# **Review of the Bingham Wind Project Visual Impact Assessment**

## **Part 1: Adequacy**

**James F. Palmer**

Prepared for  
Department of Environmental Protection  
Augusta, Maine

**Figure 2.** Visual Absorption Capability as illustrated in the US Forest Service’s Landscape Aesthetics (p. C-7).

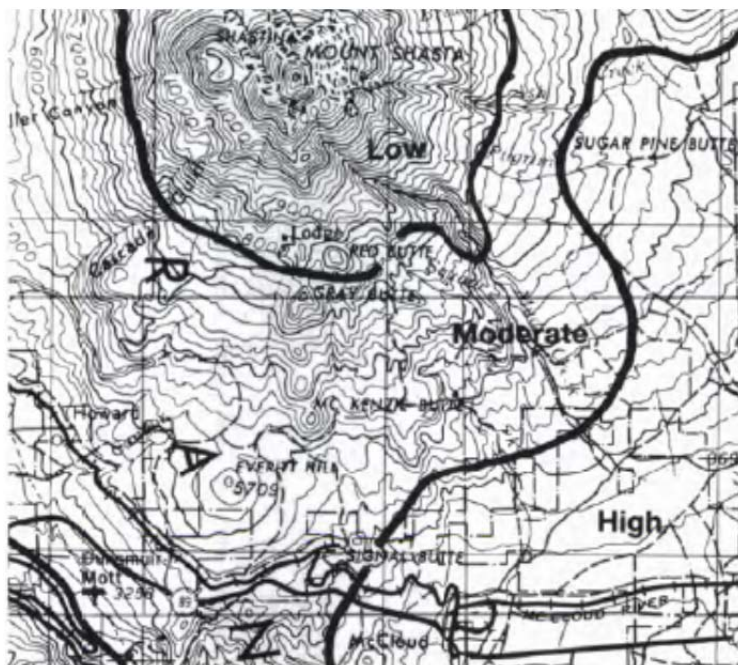
However, even at the conceptual level it does not make sense that one would characterize ridgelines (i.e., high points) with a 65-foot forest cover as having the capability to visually

absorb wind turbines that are greater than 300 feet to the turbine hub and almost 500 feet to an upright blade tip. It is reasonable to assume that this is the reason that “the [Maine] Legislature recognizes that wind turbines are potentially a highly visible feature of the landscape”<sup>26</sup> and that “a finding by the primary siting authority that the development's generating facilities are a highly visible feature in the landscape is not a solely sufficient basis for determination that an expedited wind energy project has an unreasonable adverse effect on the scenic character.”<sup>27</sup> While the US Forest Service references to VAC concern visual impacts that are below the forest canopy (e.g., harvest openings), the mapped example that they provide shows that high-points have Low VAC while valleys have High VAC, as shown in Figure 2.

**Figure 3.** This illustration, LandWorks states that a “house on a ridgetop creates skylining, more visible unnatural form breaks treeline” (LandWorks 2006, p. 3.10)

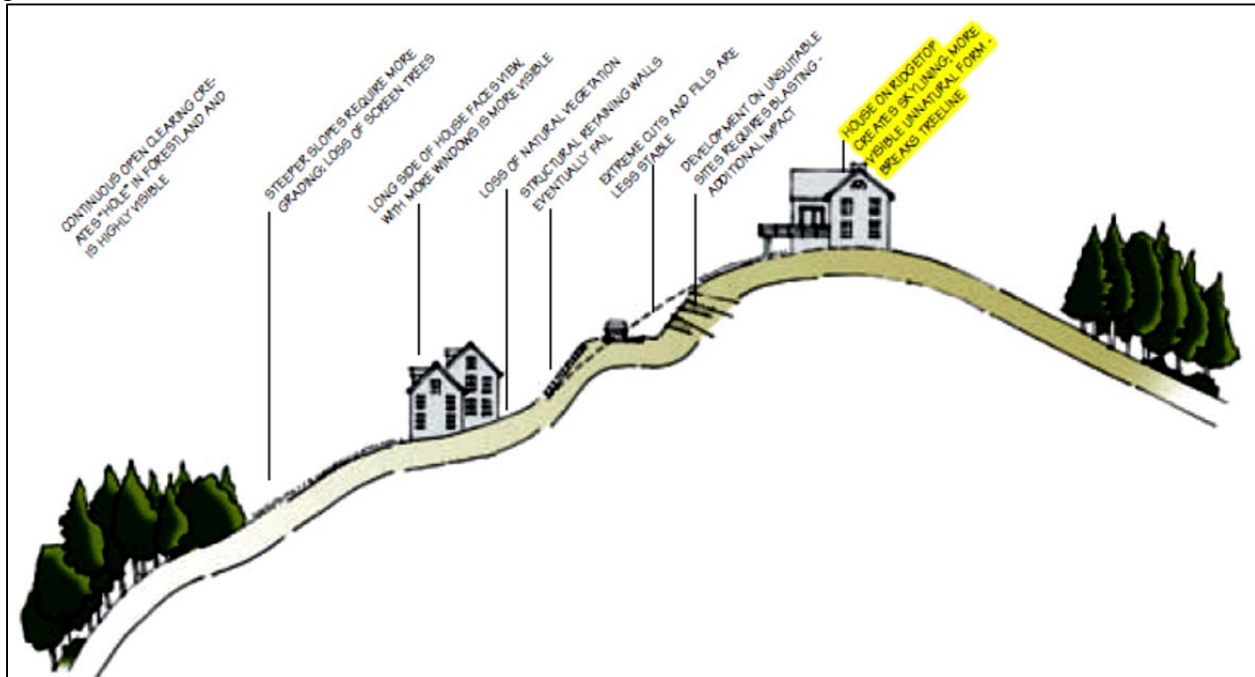
LandWorks illustrated the problem of how houses on ridgelines can present highly visible unnatural forms that break the skyline, as shown in Figure 3. If ridgelines in cannot visual

absorb a 50-foot residential structure that uses local materials and architectural styles, how can they visually absorb a 492-foot white wind turbine that has 184-foot blades moving around a point 308 feet in the air?
